RE: Tomichi Pit Sketch Plan - Processing Site Location Alternative

Based on feedback from the Gunnison, CO planning commission, Gunnison Valley Properties has developed an alternative processing site and mining plan to address concerns expressed by the planning commission during the September 7, 2012 work session.

Map 4.2 - Alternate Development Layout
Tomichi Pit
Gunnison Valley Properties

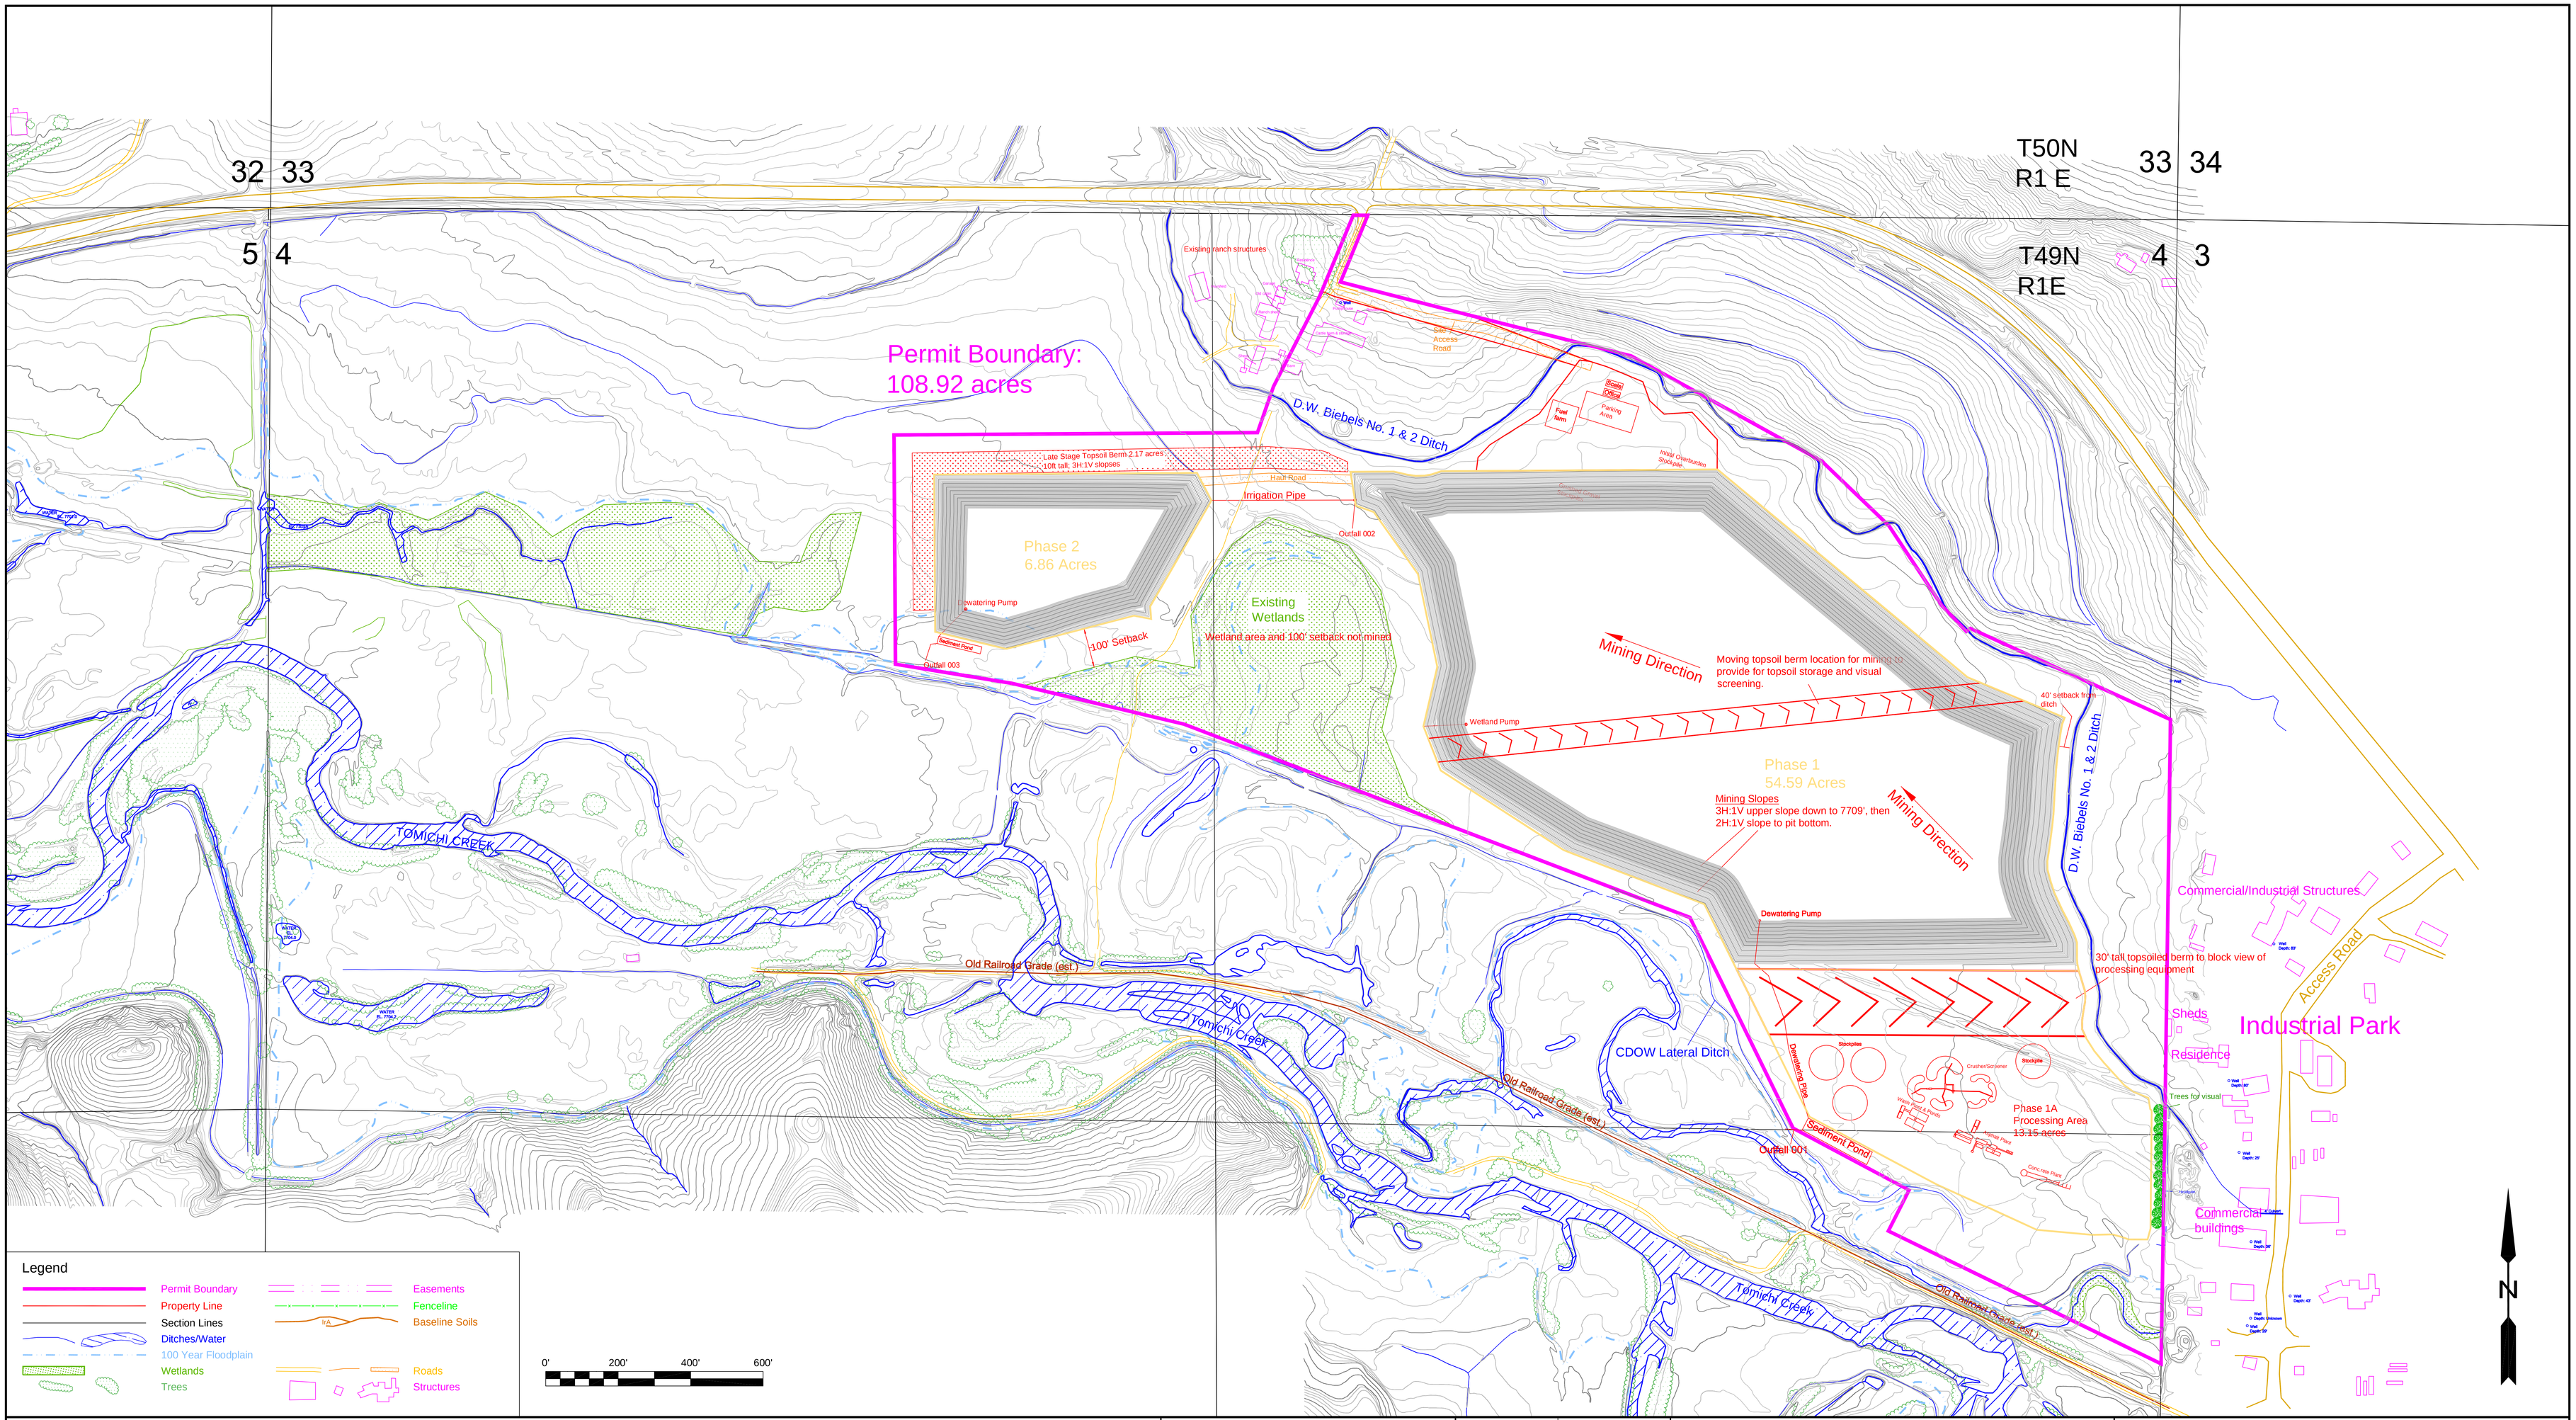
Considering the planning commissions comments regarding the location of the processing equipment, an alternative mining plan with a different processing location has been developed. This plan can be seen on *Map 4.2 – Alternate Development Layout*.

In this new plan, the processing equipment and stockpiles spends most of the mine life on the surface in the southeast corner. Once mining of the rest of Phase 1 and all of Phase 2 is complete, the operator can move the processing equipment to the floor of the mined out Phase 1 and mine the processing area. During the time that the processing area is on the surface, a 30 foot tall berm will be in place along the north side of the processing area. This berm will be built with overburden and topsoil stripped during initial mining, and the vegetated. The berm will obscure most of the processing activities, with taller portions of the asphalt plant and the top of maximum sized stockpiles being partially visible.

Figure 1

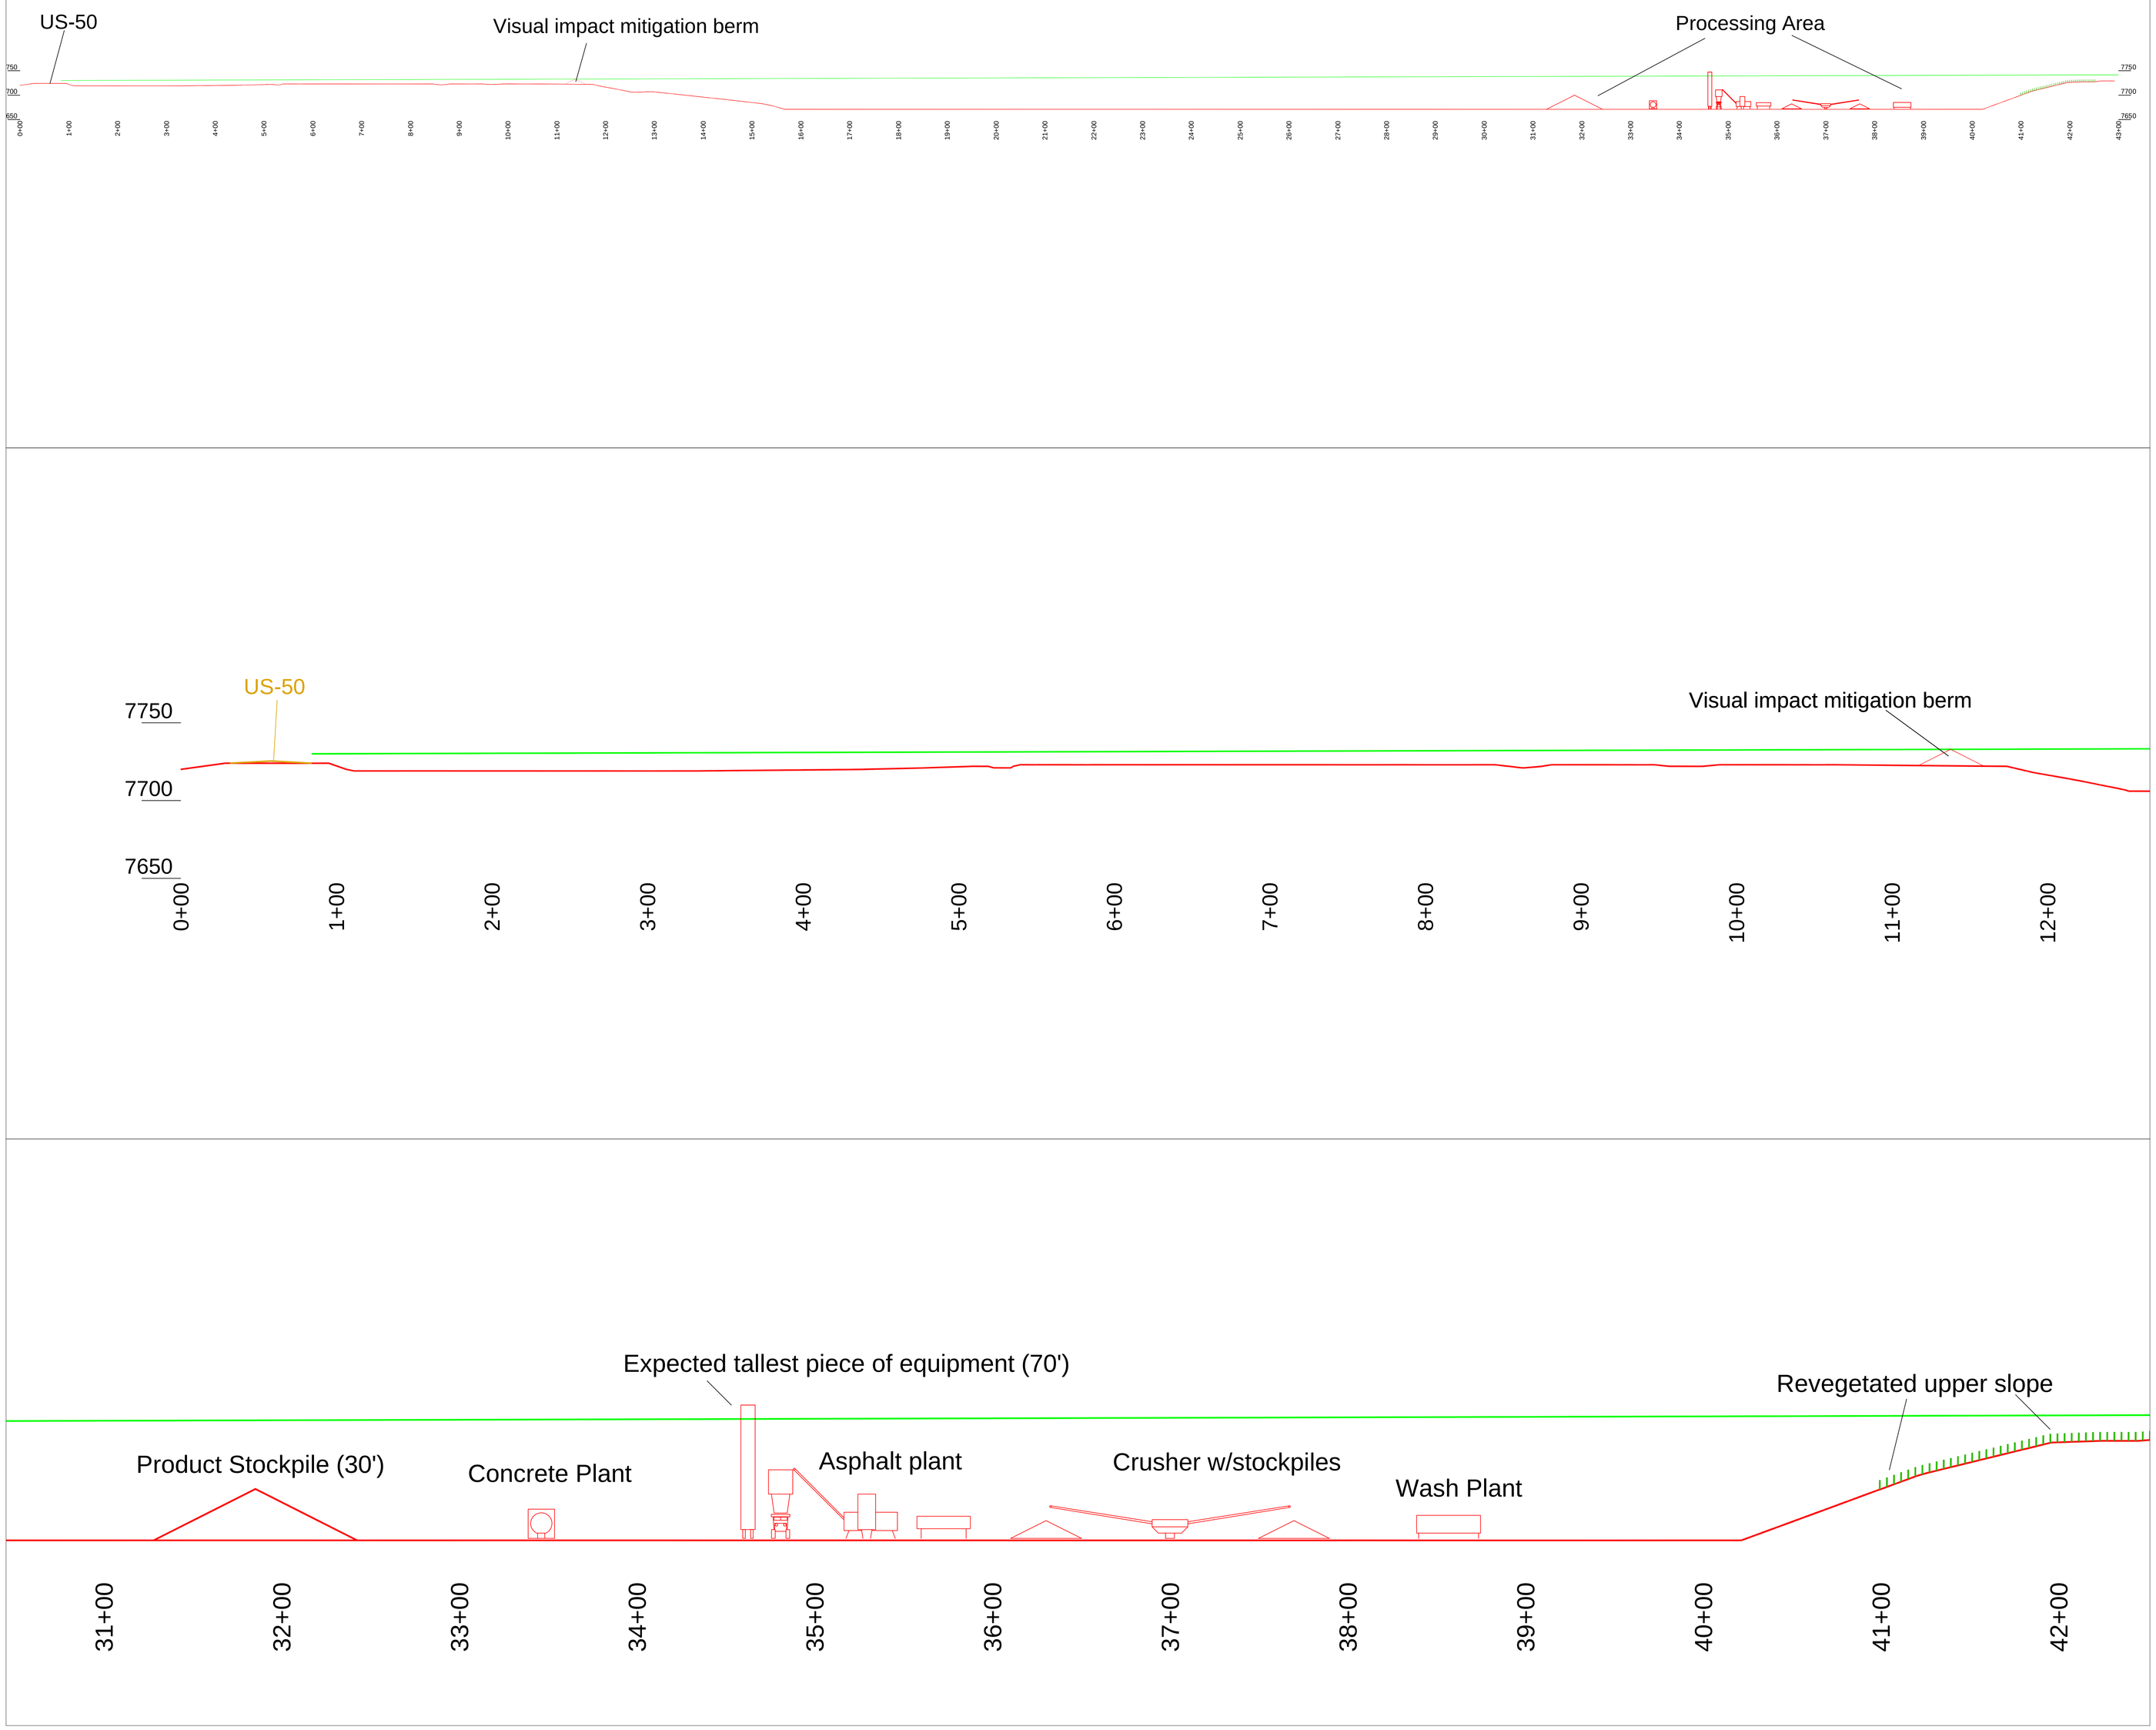
The visual impact mitigation berm will still be built ahead of the mining pit to obscure the pit as in the current mining plan. A cross section showing the line of sights for the original plan can be seen on Figure 1, with the alternative mining plan's visual cross section on Figure 2. The combination of berms will minimize the amount of the processing facility at the southeast corner of the site will maximize the distance between US-50 and the processing activity throughout the mine life.
